# **SERVICE BULLETIN**

**NACELLE — EXHAUST — OVERHEAT DETECTOR HARNESS INSTALLATION, UPPER THRUST  
REVERSER HALF — MODIFICATION OF**

**V2500-D5**

**V2500-NAC-78-0149**

Overheat Detector Harness Installation Modification  
Figure 1 (Sheet 1)

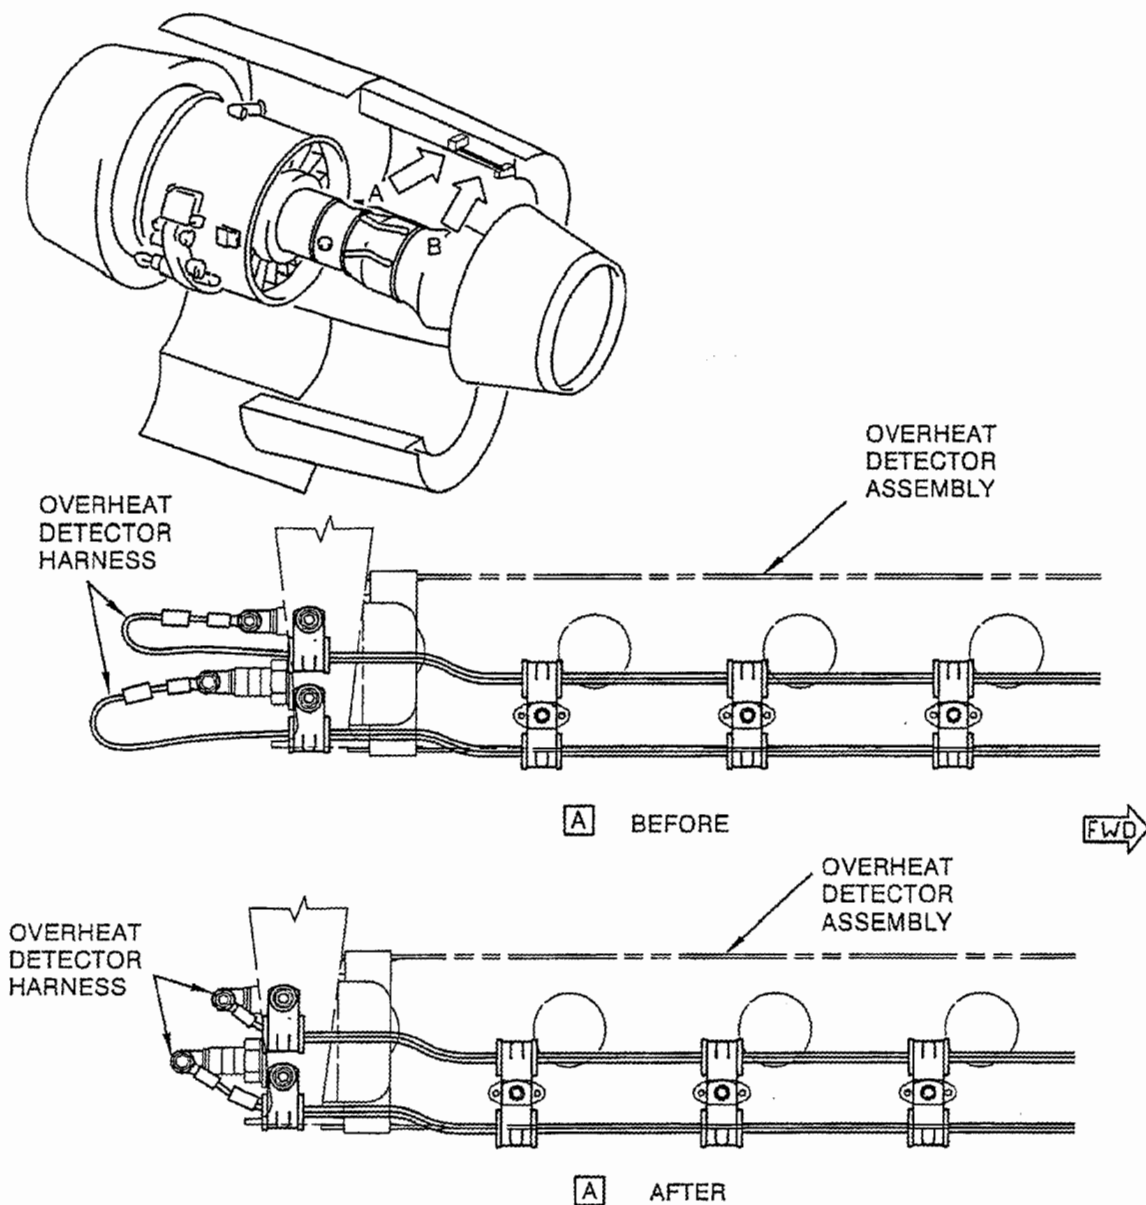
- (1) Remove the excess length at the aft end of the outboard overheat detector harness. Make the harness installation in this area look the same as shown in Figure 1 (Sheet 1) Detail A.
- (2) Distribute the remaining excess length of the overheat detector harness forward. Be careful not to cause interference with other components.

Overheat Detector Harness Installation Modification  
Figure 1 (Sheet 2)

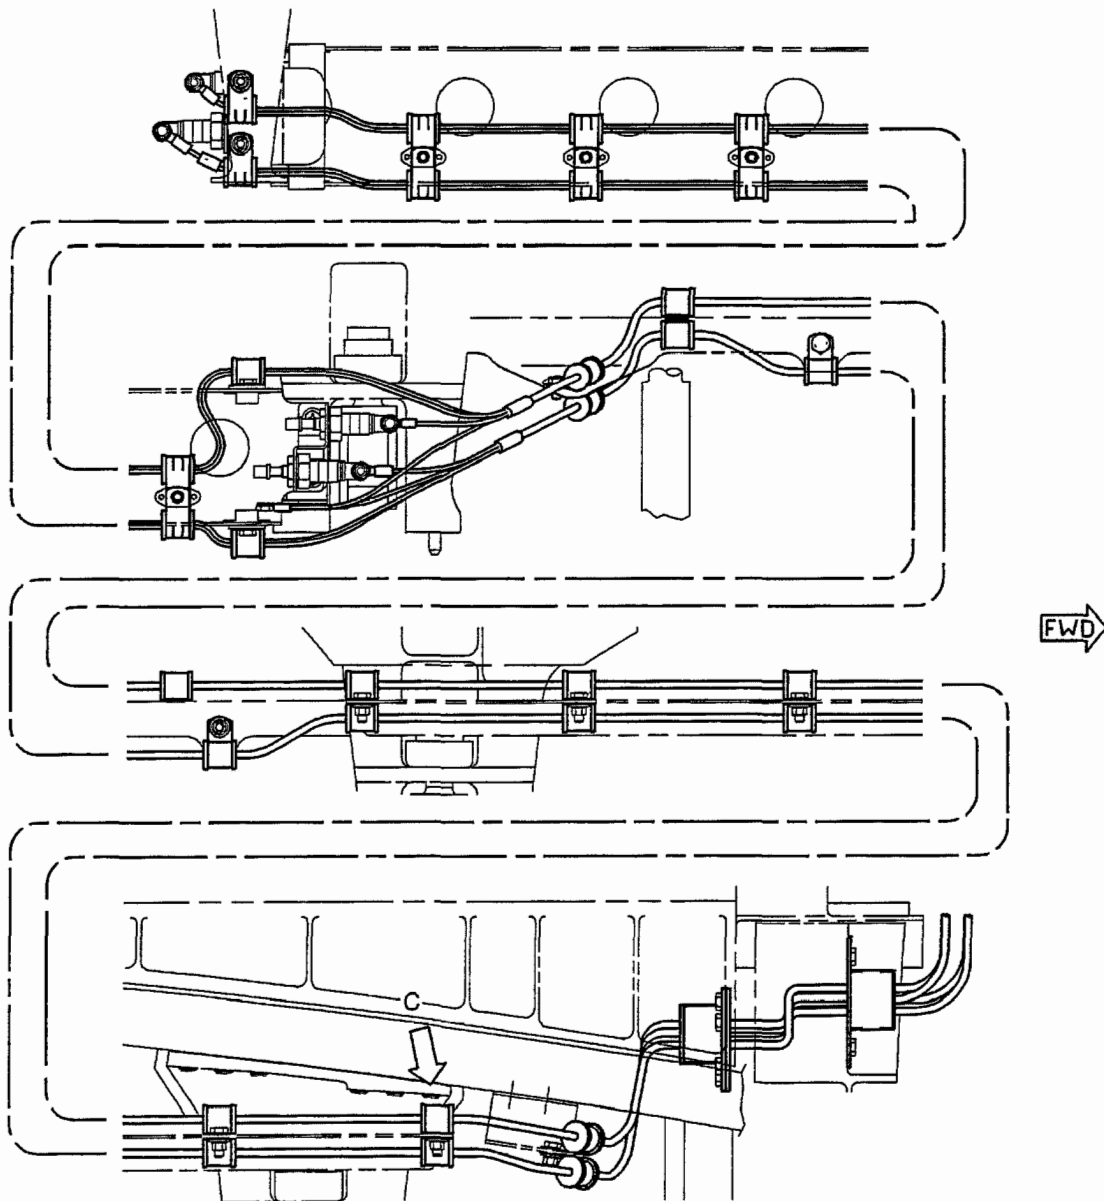
NOTE: A suggested ideal installation of the harness is shown in Figure 1 (Sheet 2) Detail B. To make the installation like this, it is necessary to loosen all the clamps between the aft end of the overheat detector assembly and the forward bulkhead. It may also be necessary to remove and install some of the wire harness ties and the bulkhead fire wall fittings.

Overheat Detector Harness Installation Modification  
Figure 1 (Sheet 3)

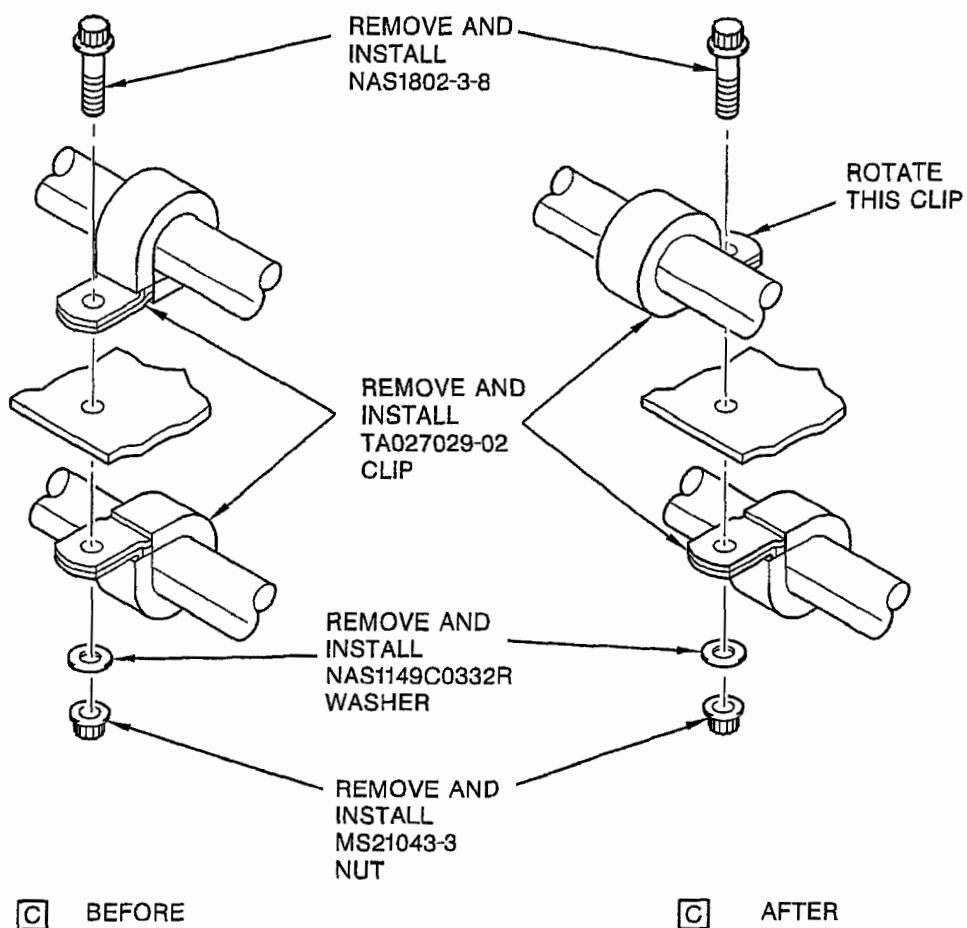
- (3) Remove the nut, washer, bolt, and clip. Reverse the clip and install the bolt, washer, and nut. Refer to Figure 1 (Sheet 3) Detail C. This is done to eliminate the possibility of interference between the harness and the thrust reverser heat shield.
